ADDENDUM NO. 01

ELOP Year Two Track Upgrades

PROJECT NAME: Thomas Jefferson MS – ELOP Year Two

DARDEN PROJECT NO. 2468.2

AD1-LX01

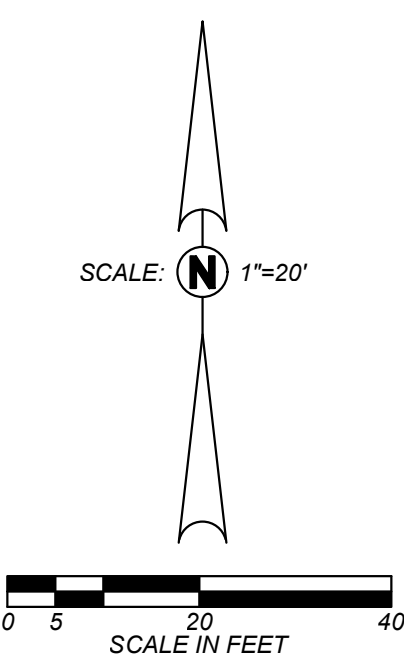
AD1-L01 Refer to Sheet SD/L102, PARTIAL IRRIGATION PLAN:

1. Irrigation revised to include tree bubblers on the west and south of the tennis courts.
2. Irrigation Legend Revised

AD1-LX02

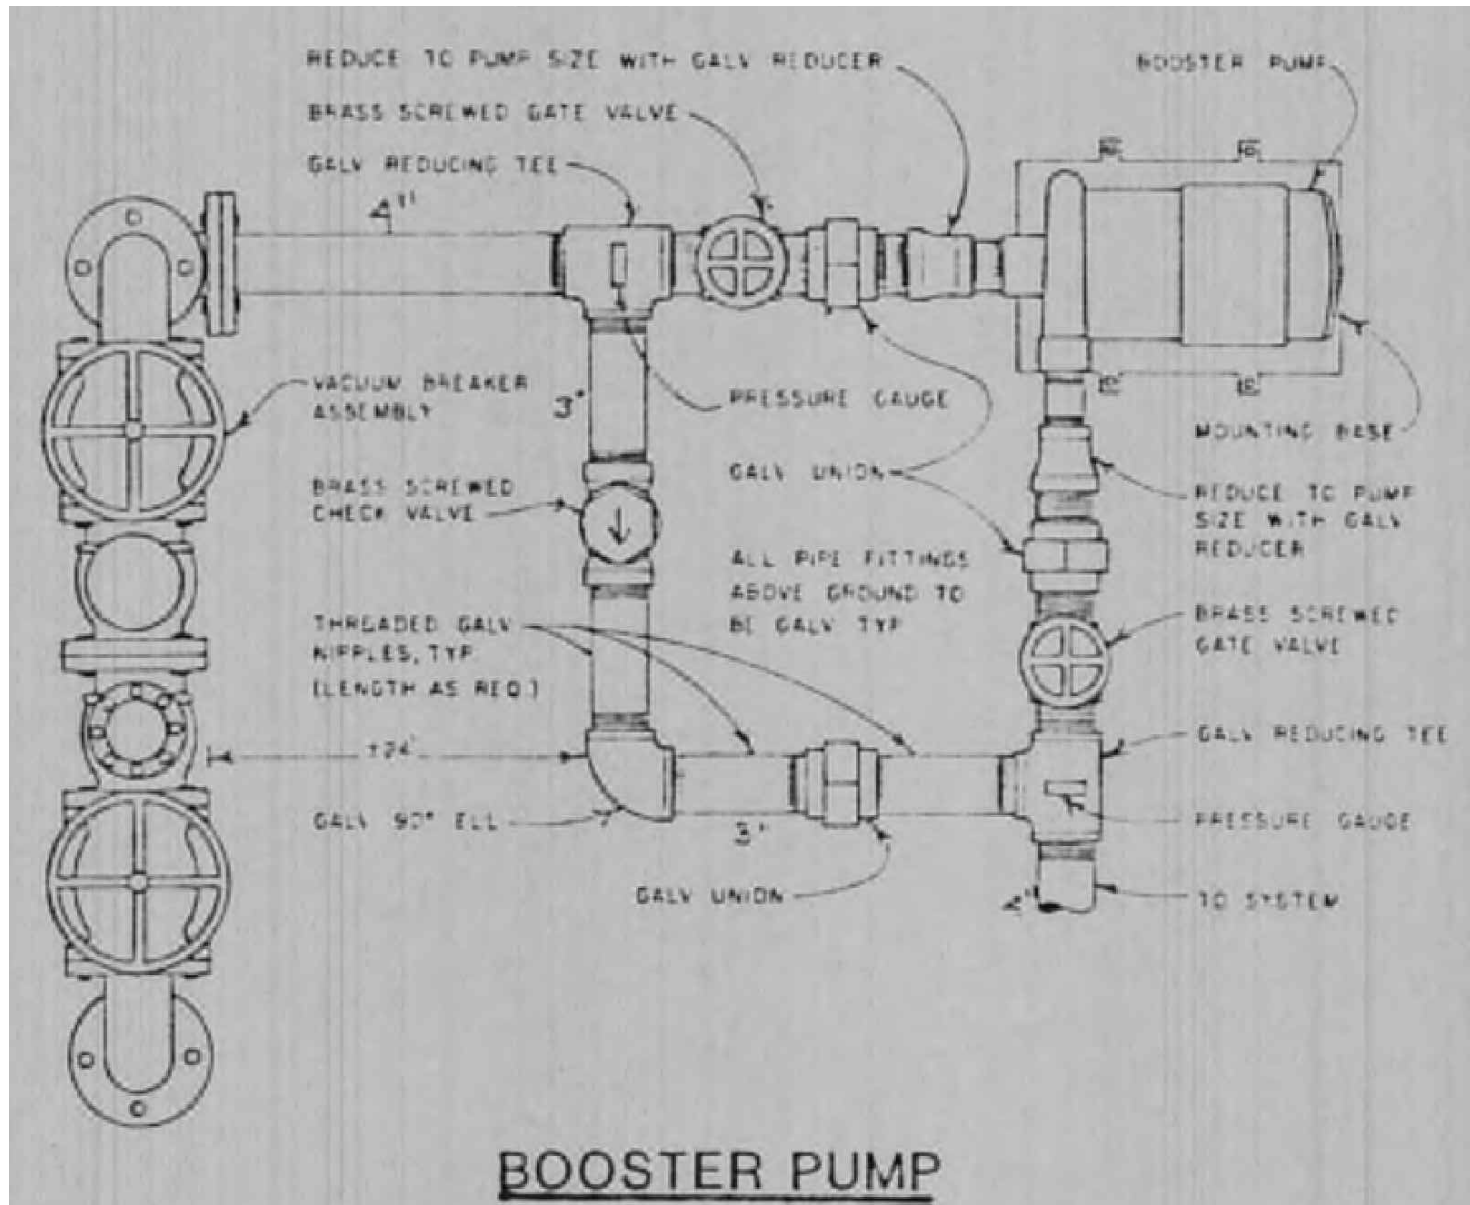
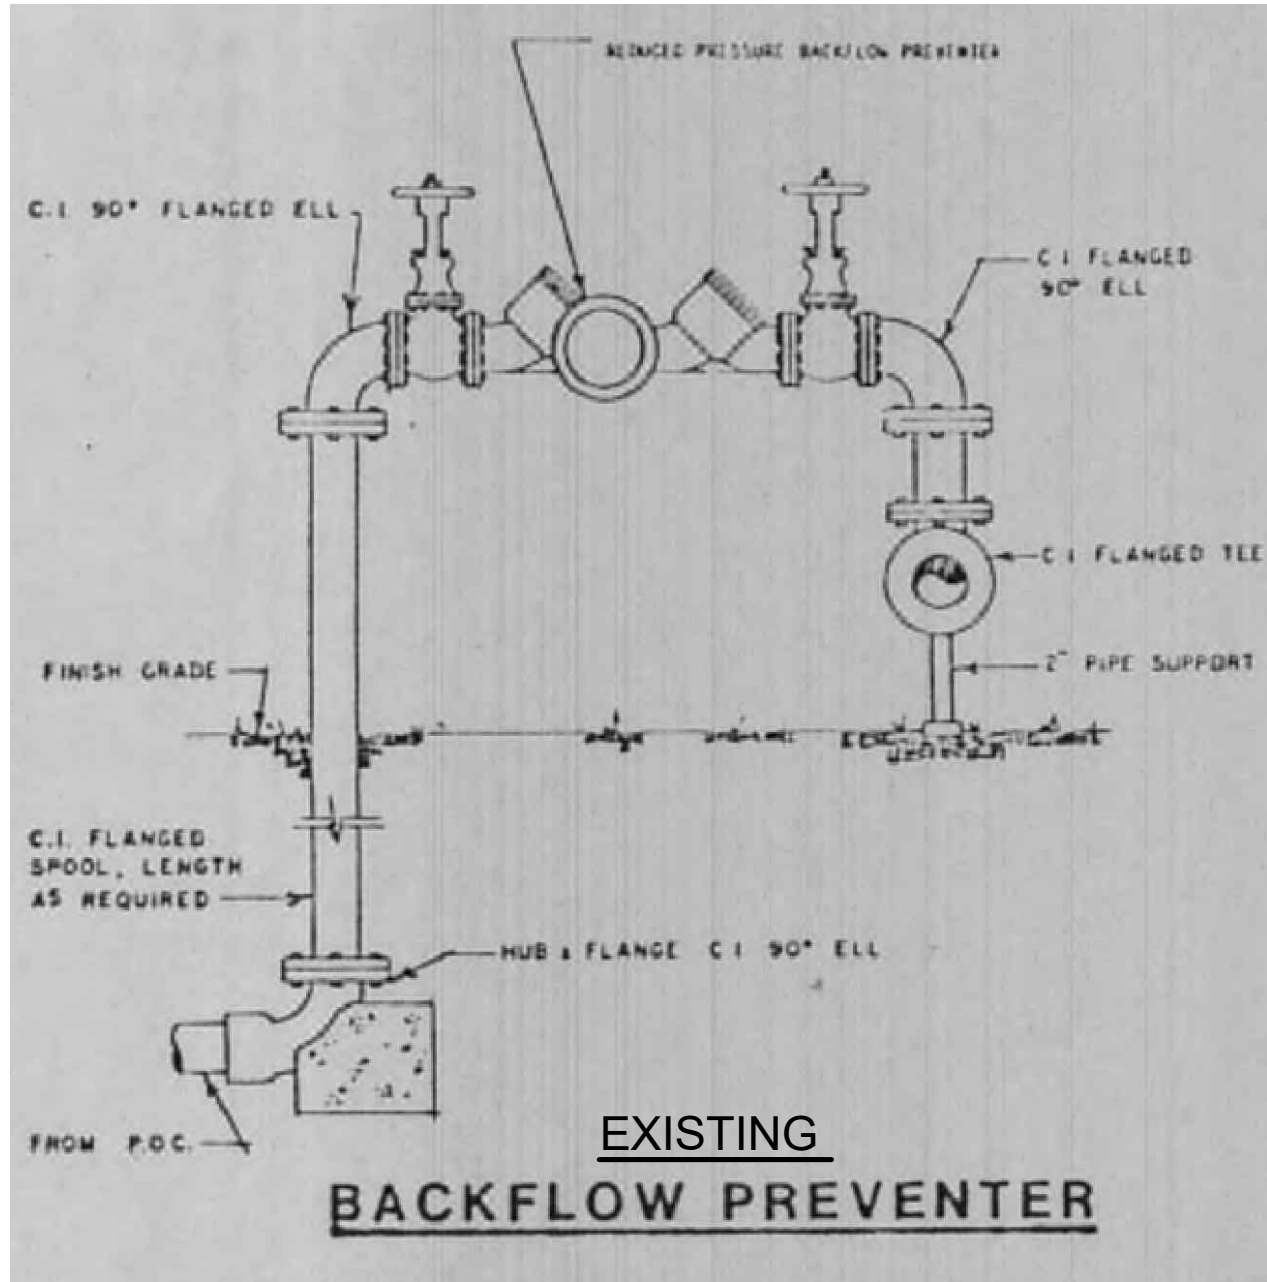
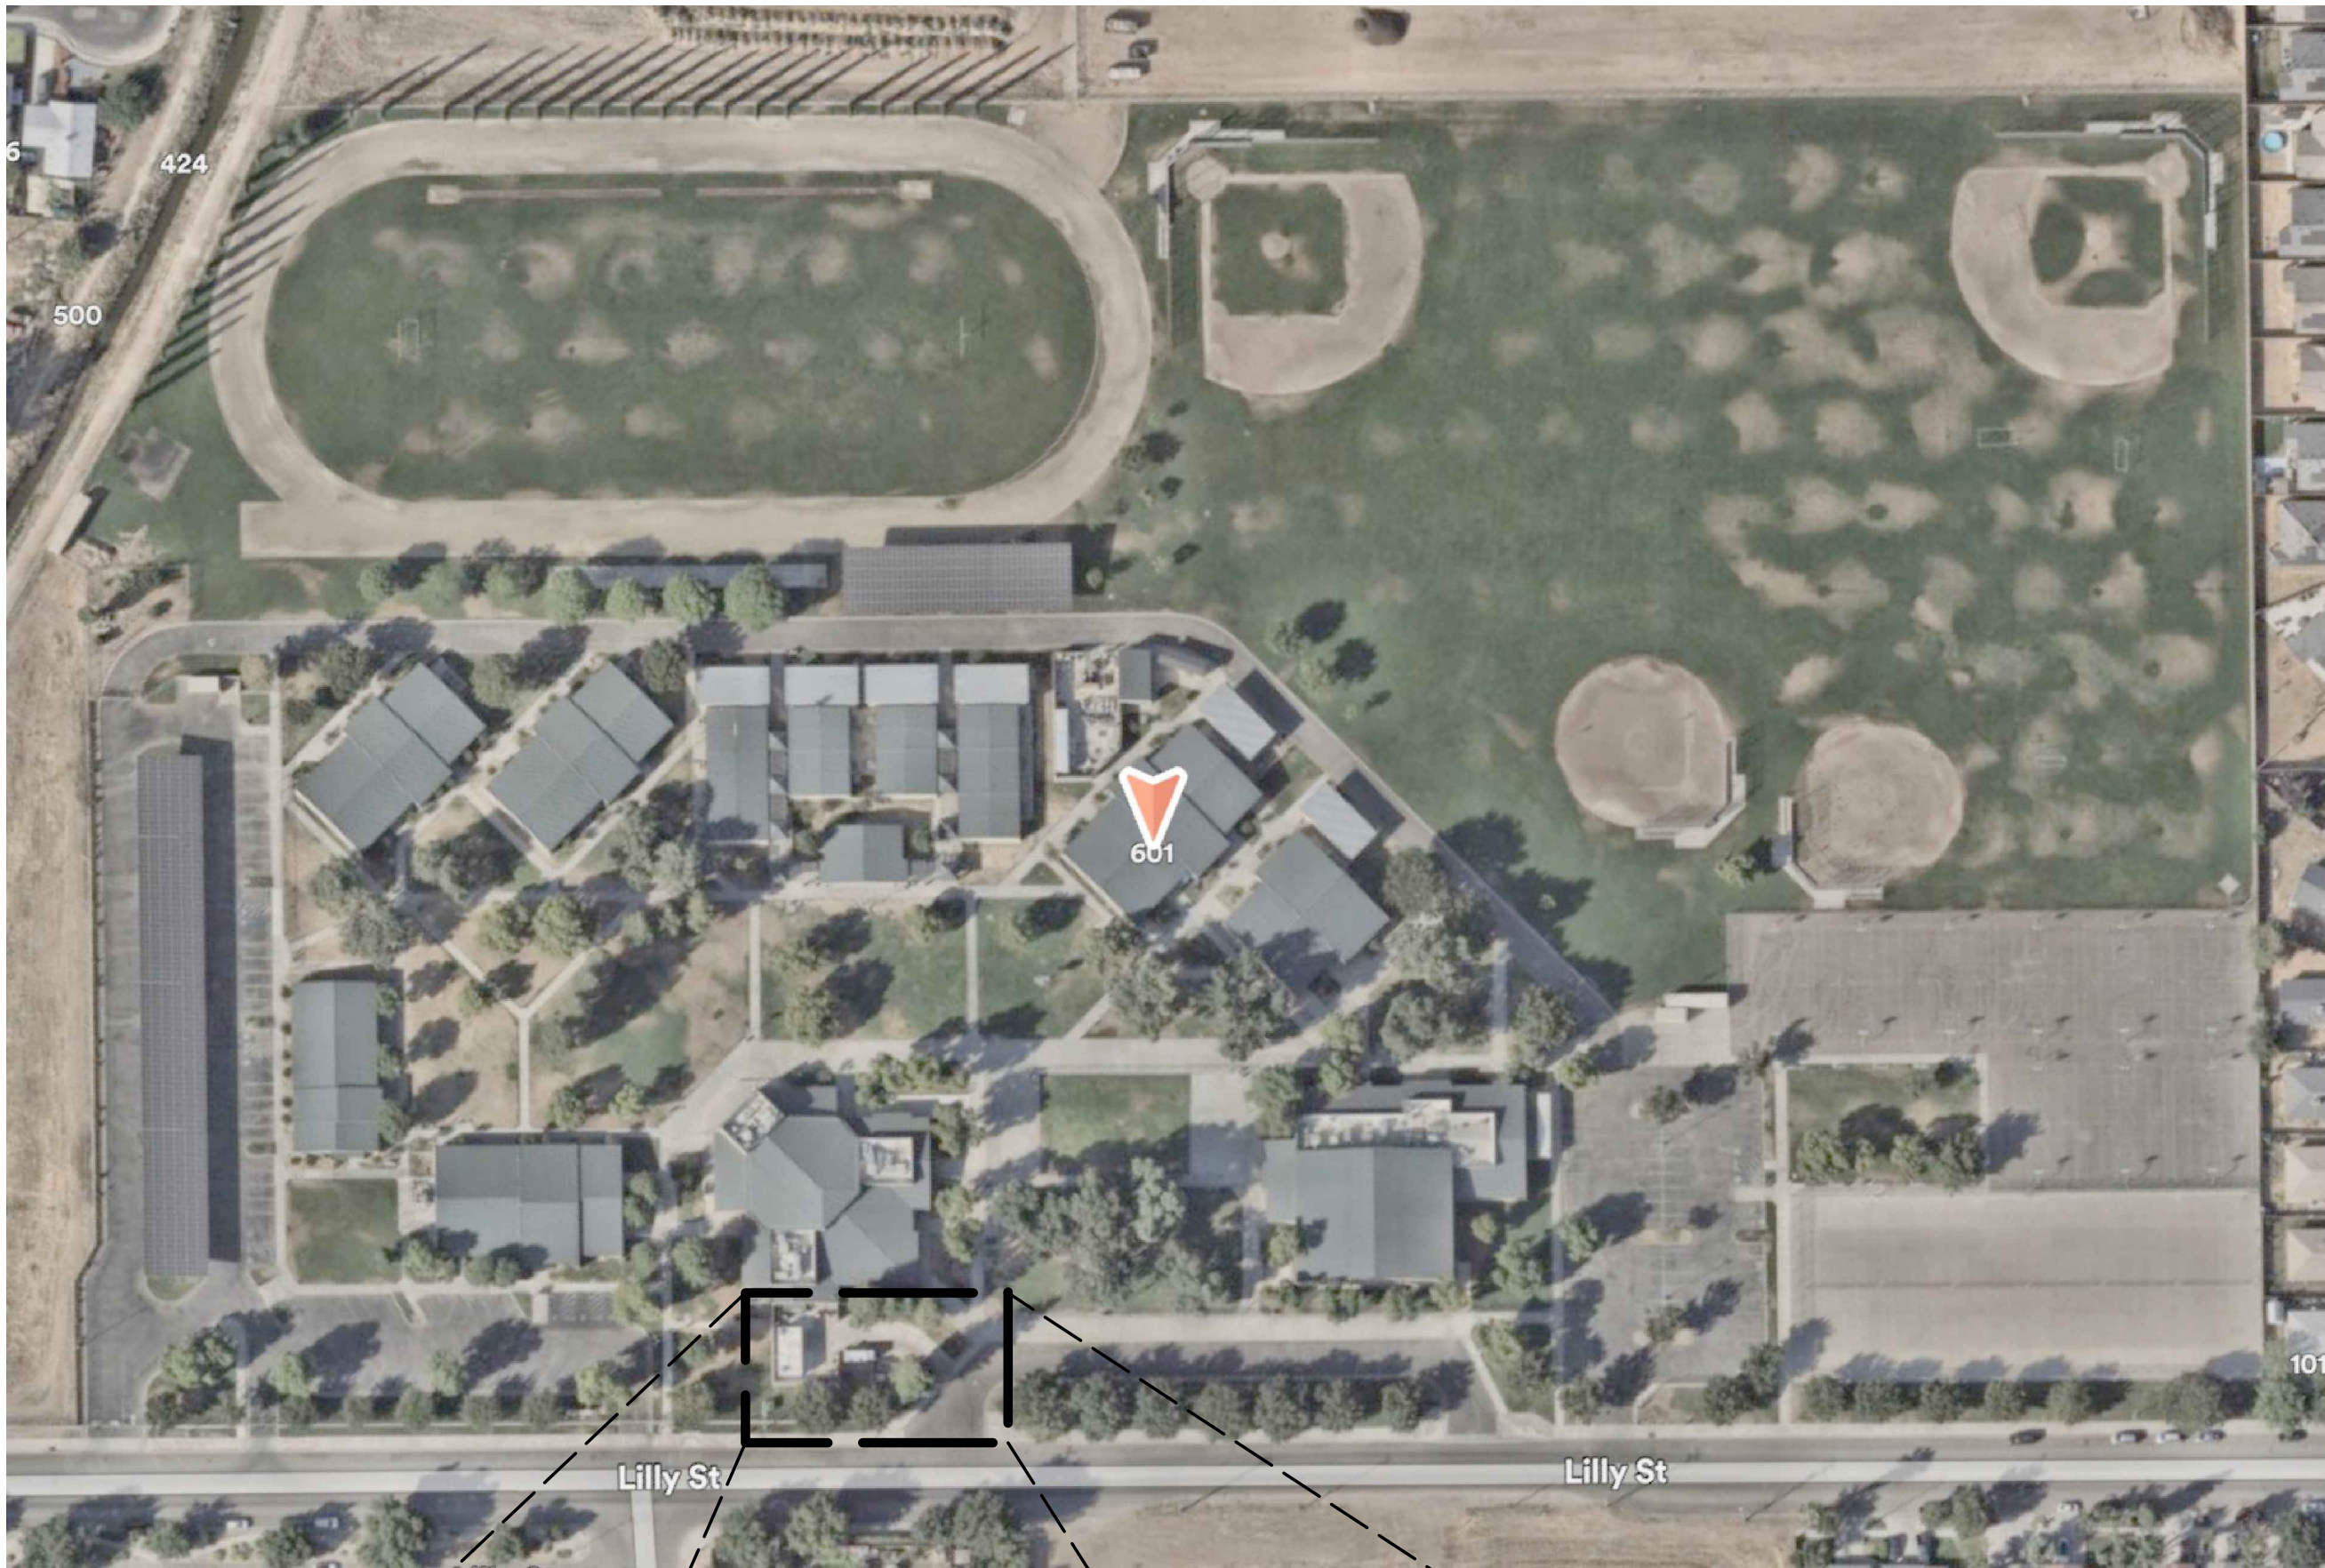
AD1-L02 Refer to Sheet SD/L104, IRRIGATION DETAILS:

1. Detail G has been revised.
